Project Name | BCWD Permit 23-10 Curio Dance Studio**Date** | 06/09/2023**To / Contact info** | BCWD Board of Managers**Cc / Contact info** | T.J. Rose Larson Engineering**Cc / Contact info** | Karen Kill, Administrator / BCWD**From / Contact info** | Camilla Correll, PE / EOR; John Sarafolean, EOR**Regarding** | Permit Application No. 23-10 Engineer's Report

Applicant: Patricia Schaber, CDS Properties LLC**Permit Submittal Date:** 05/12/2023**Completeness Determination:** 06/02/2023**Board Action Required By:** 08/01/2023**Review based on BCWD Rules effective April 1, 2020****Recommendation: Approve with Conditions**

Figure 1: Site plan for Curio Dance Studio.

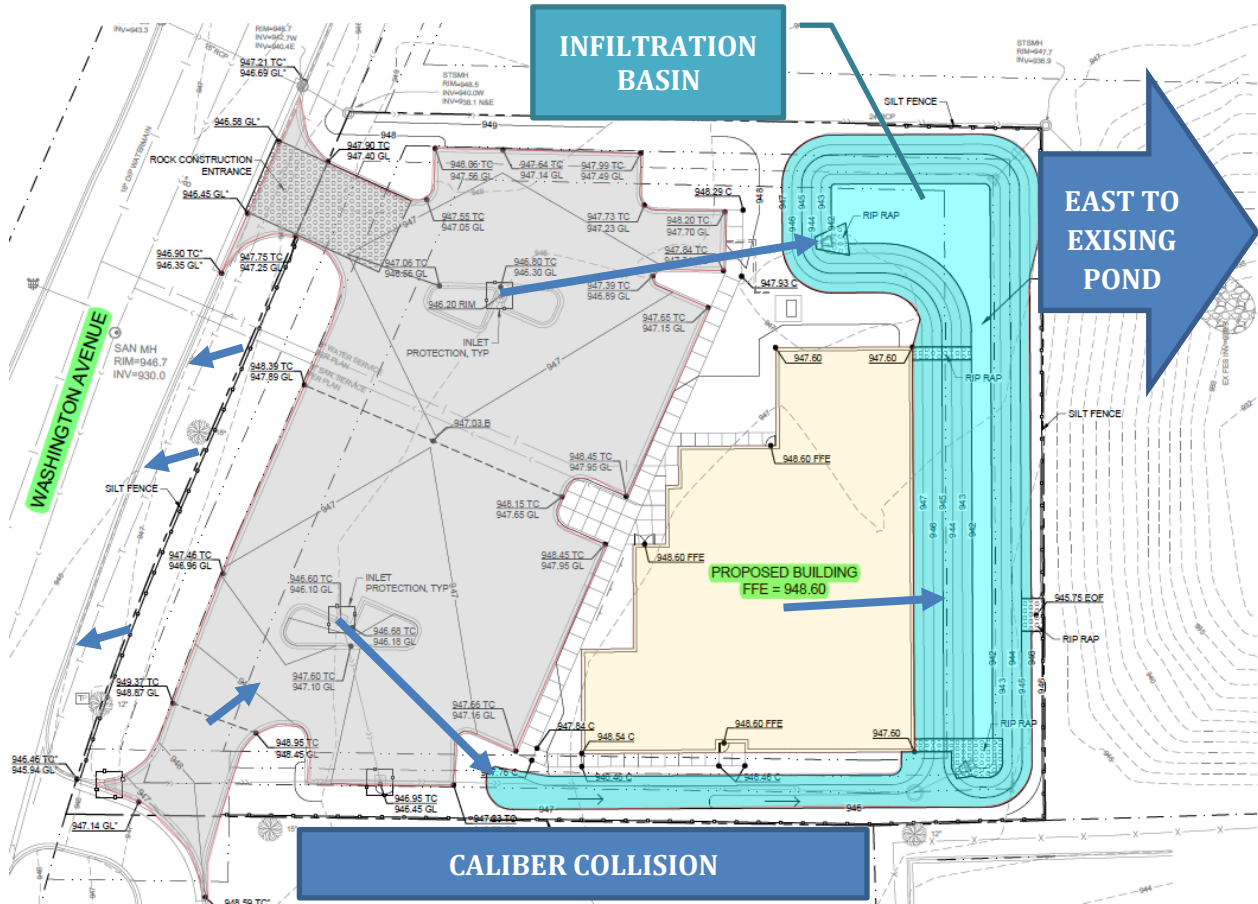
- 2-1. The submitted civil plan set is unsigned and therefore not for construction. Provide BCWD with the final Civil Plan Set prior to start of construction. (BCWD 2.7.9)
- 2-2. Submit stormwater facility maintenance declaration in a form acceptable to the District for review and approval prior to recordation, and proof of recordation with Washington County. A template is available under the permit section of the District's website. (BCWD Rule 2.6).
- 2-3. Provide documentation as to the status of a National Pollutant Discharge Elimination System stormwater permit for the project from the Minnesota pollution Control Agency and provide the Storm Water Pollution Prevention Plan (SWPPP) as it becomes available (BCWD Rule 2.7.15).

- a) *Provide the Landscaping Plan for the project and include specifications for topsoil, identify seed mix or sod for areas outside of the infiltration basin.*
- b) *Add the construction limits to the plan set.*
- c) *Add redundant silt fence along the east side of the site. The disturbed area is within 50 feet of a surface water.*
- d) *Change the rock construction entrance rock size to 1.5" to 3", as recommended in the Minnesota Stormwater Manual.*
- e) *Add a note to the plan concerning construction of the infiltration basin stating, "excavation must extend to SP soils identified in geotechnical report."*

- 3-1. Address erosion control comments a through e above in a revised plan set (BCWD 3.2.2).
- 3-2. Provide the contact information for the erosion and sediment control responsible party during construction once a contractor is selected. Provide the District with contact information for the Erosion Control Supervisor and the construction schedule when available (BCWD 3.3.2).
